SUPER LAW GROUP, LLC

January 27, 2016

Re: **Comments of Sierra Club Regarding Renewal of
Schiller Station NPDES Permit No. NH0001473**

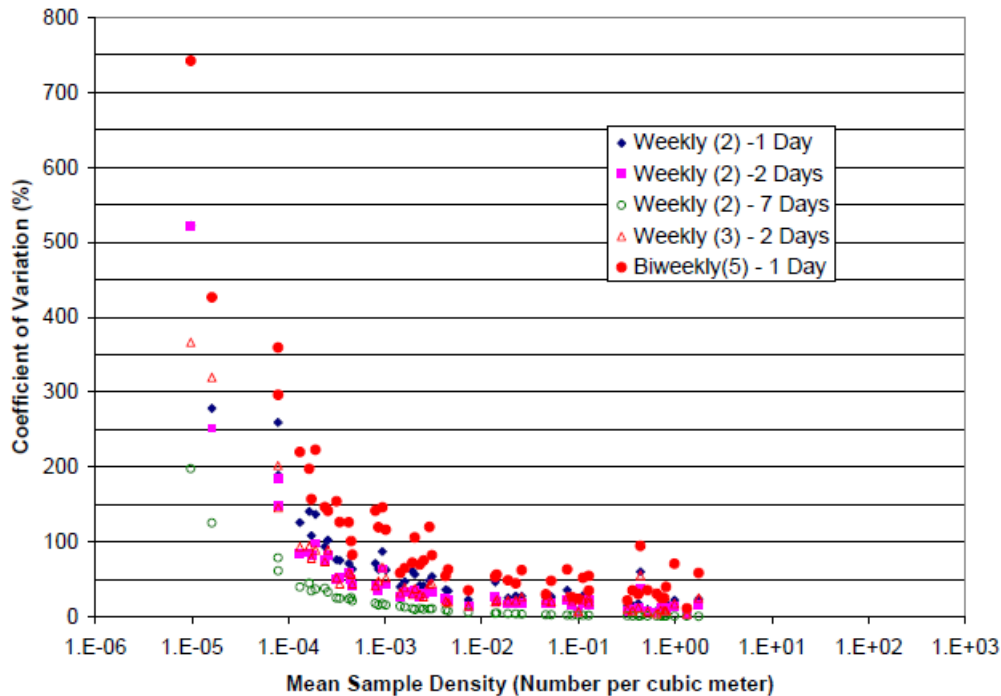
Variability in entrainment rates increases when entrainment rates are high compared to when they are low. Thus, it would make sense to sample at a higher frequency during periods of high entrainment to reduce the uncertainty when estimating annual entrainment. In theory, this was partly addressed at Schiller except for the months of May and September which were periods when significant entrainment of ichthyoplankton and crustaceans occurred (Tables 2.4 and 2.6). As mentioned above, sampling occurred one day per week at the CWIS during periods of expected higher entrainment and during times of expected lower entrainment, sampling occurred on a biweekly basis. However, as shown below in Figure 3.1, entrainment sampling frequency strongly affects the precision of annual entrainment estimates. For biweekly sampling, the coefficient of variation (CV) of annual entrainment estimates ranged from about 50% at the highest densities to 750% at the lowest densities. For sampling one day per week (Scenario 2), CV ranged from over 250% at the lowest densities to less than 50% at the highest densities. Sampling twice per week on random days (Scenario 2) decreased the CV and sampling 7 days a week (Scenario 2) decreased the CV even further (although sampling every day is cost prohibitive). In Scenario 3 where sampling was also conducted twice per week but on consecutive days, the CV was higher than when weekly sampling was conducted on random days (EPRI 2005a). In all cases presented in Figure 3.1, there were four events per day with 100 m³ of water per sample which is similar to that which was used at Schiller (Normandeau 2008). A more robust sampling design of one or more samples/week especially during periods of high entrainment is recommended for verification monitoring following BTA selection.

Figure 3.3 Mean Larval Fish Density (#/100 m³ sampled) by Week (all Life Stages Pooled) for Entrainment Samples Collected at Schiller Station for the Period of August 31, 2006 to September 27, 2007

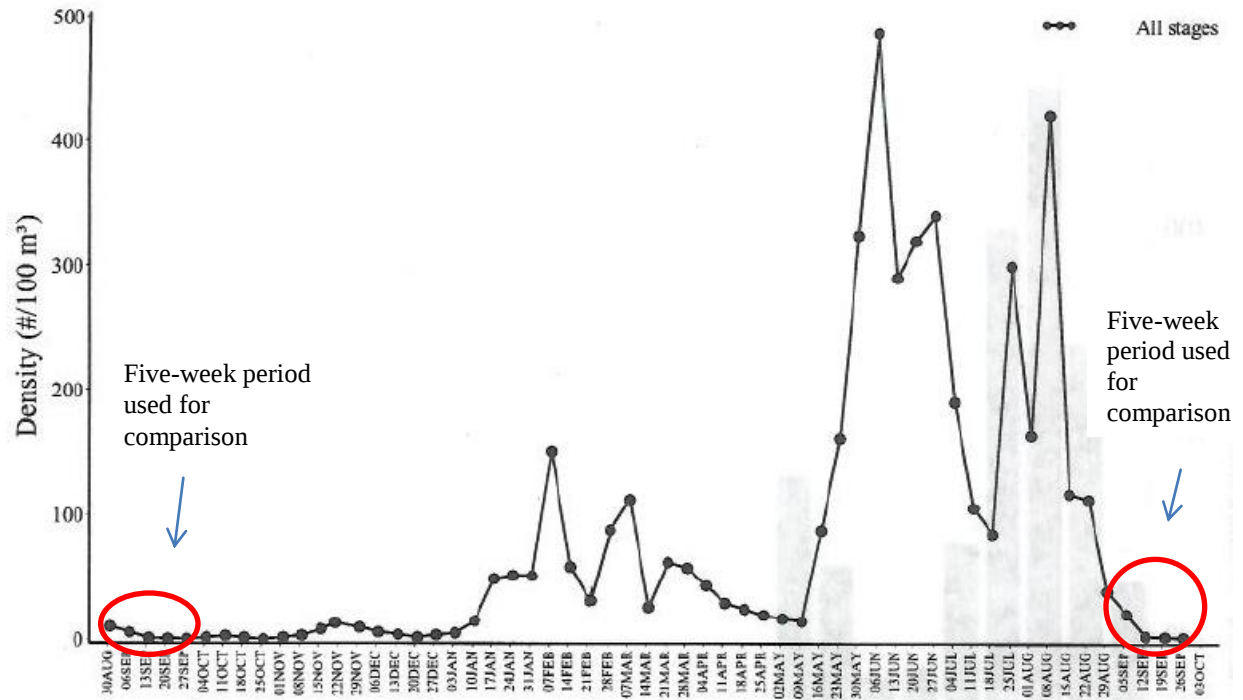
- No Seasonal Data: Data only presented over a five (5) week period and no seasonal component.
- Limited Data: The year-to-year comparisons are based only on five-(5) data points for each over the 5 week period from August 31-September 28, 2006 and August 30-September 27, 2007. This period (5 weeks) represents less than 15% of the entire year sampled. It is important to note that these samples were also based on biweekly samples, not weekly, which was done during the key entrainment periods. Entrainment sampling occurred weekly during periods of expected higher entrainment (13 weeks in June-August 2007 and 13 weeks in January-Mach 2007). EPRI (2005a) reviewed entrainment data at Indian Point which shows that sampling frequency strongly affects the precision of annual entrainment estimates. For biweekly sampling, the coefficient of variation (CV) of annual entrainment estimates ranged from about 50% at the highest densities to 750% at the lowest densities. Comparisons used at Schiller were at the lower densities of ichthyoplankton abundance (see Figures 3.3 and 3.4). For this reason, it is believed that these comparisons are not considered statistically valid for an entire year of entrainment.

Figure 3.5 Mean Fish Density (#/million gallons) by Week for Impingement Samples Collected at Schiller (Units 4, 5, and 6 combined) for the period August 31, 2006 to September 27, 2007

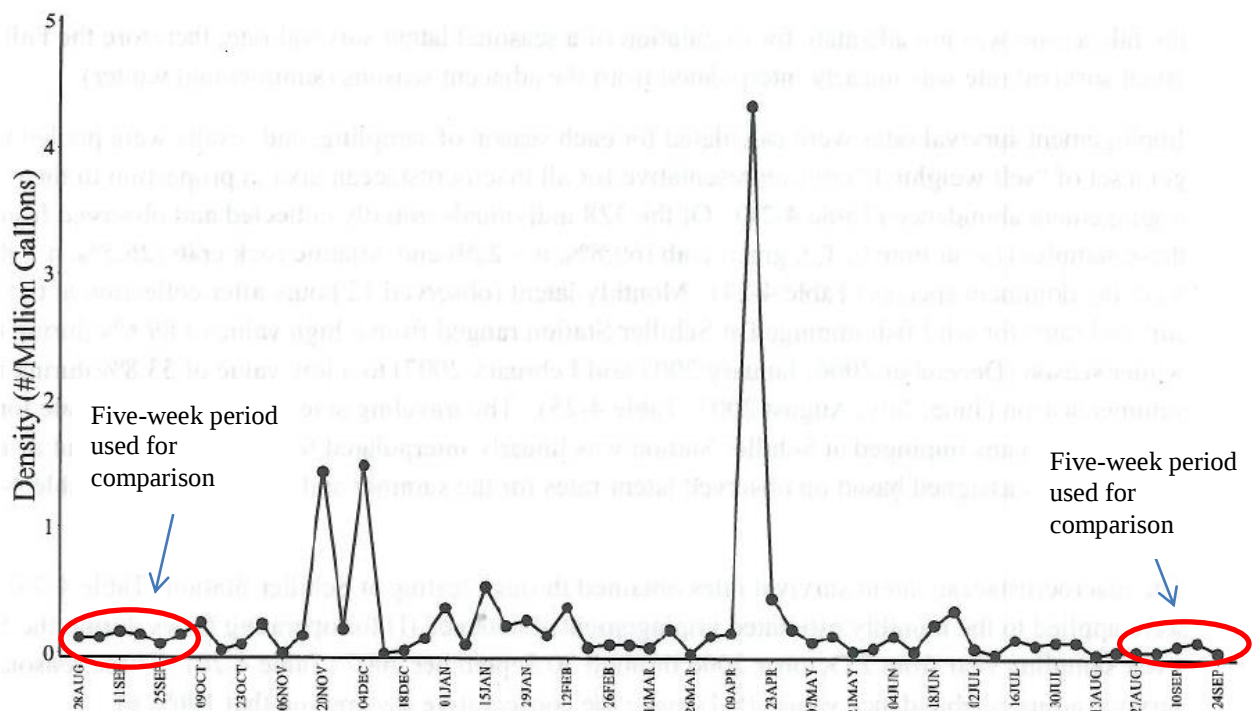
- No Seasonal Data: Data only presented over a five (5) week period for 2006 (August 31 to September 28) and 2007 (August 30 to September 27) and no seasonal component.
- Key Impingement Periods. The key impingement period for fish impingement is clearly not during end of August to end of September. The adjusted fish densities impinged (see Table 2.13) represent less than 4% of total annual impingement for September 2007. Figure 4.1 of Normandeau (2008) shows the relatively low densities for comparison for the sampling month comparison for which are clearly not representative of higher periods of impingement (see Figure 3.5). The same occurs for macrocrustacea.
- Comparisons cannot be extrapolated for an entire year since there is no seasonal component and at a period when densities are naturally low.
